**STAFF REPORT 02-09-2022 MEETING**

**APPLICATION NUMBER: 22-7669**

**ADDRESS: 1405 GRISWOLD**

**SCOPE: REPLACE STOREFRONT SYSTEM (WORK COMPLETED WITHOUT APPROVAL)**

View **BEFORE** alterations. Google Street View, August 2018.

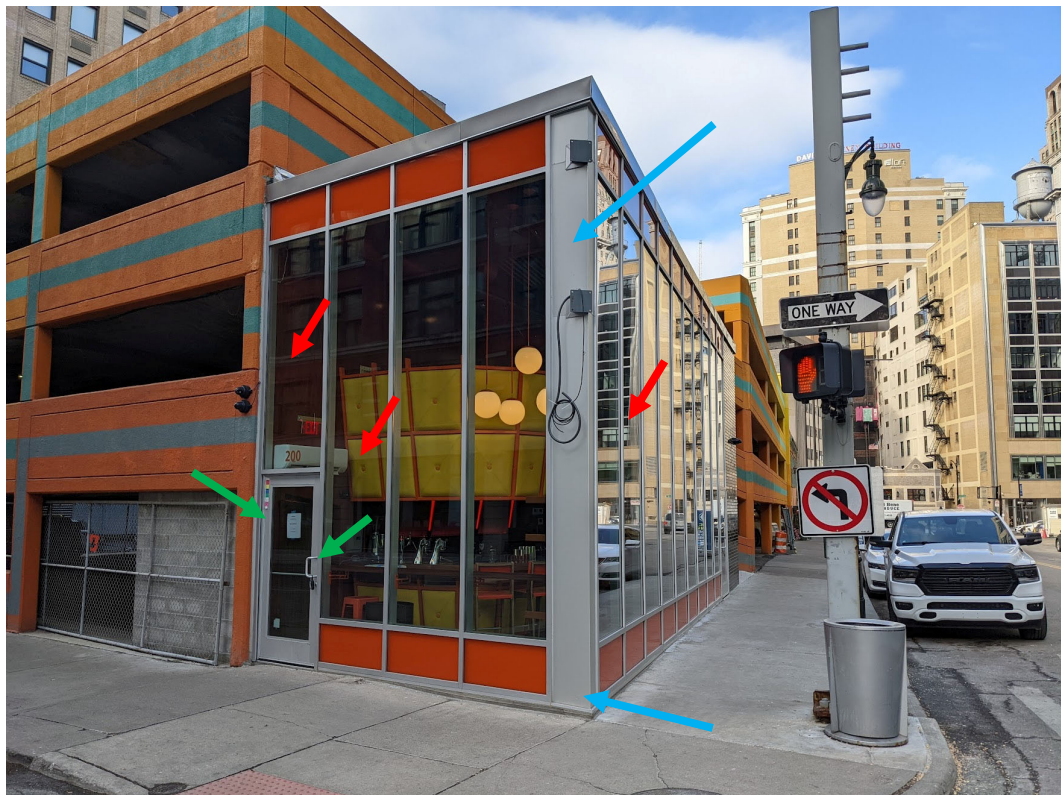
1. Delicate horizontal framing members previously dividing the columns of glass in varying patterns, and contributing a certain looseness to the overall expression, are now missing. In the shop drawings depicting the existing conditions, these are described as "random horizontal aluminum extrusions ½"-1" wide." Staff has identified that thirteen (13) of these are missing; four (4) at the Grand River side and nine (9) at the Griswold side, affecting nearly every "column" of glass. **See red arrows on photos, showing 3 of 13.**

2. The vertical mullion element at the intersection of the Griswold and Grand River elevations, at the corner, is now substantially wider, flattened out and bulky, whereas the original was recessed with complex geometry, showing additional vertical detail/shadow lines, and balanced between the Grand River and Griswold Elevations. The element is now heavily "weighted" towards the Grand River side. **See blue arrows on photos.**

3. The doors are set not into the plane of the storefront system, but markedly recessed when compared to the original planar expression. **See green arrows on photos.**

4. The door stiles at the top/sides (the aluminum members forming the door) are bulkier (wider) than the originals

5. The door handles are standard, off-the-shelf commercial handles with no resemblance to either originals or appropriate mid-century precedents.
  6. The upper structural sign mount has been relocated from the roof to the vertical corner mullion.

7. The new system's mullions are deeper than the originals (6" compared to approximately 4" previously).
  8. The visible coping band at the top of the building is wider (thicker) than the original, presumably to terminate the new roofing.

- As the original fabric has been lost, it is staff's opinion that the Commission should only approve an exact match, conditioned on mitigation of most of the disparities outlined above (additional horizontal members, corner mullion issue, etc., numbered 1-8). Per Standard 6, replacement elements "*shall match the old in design, color, texture, and other visual qualities and, where possible, materials.*"
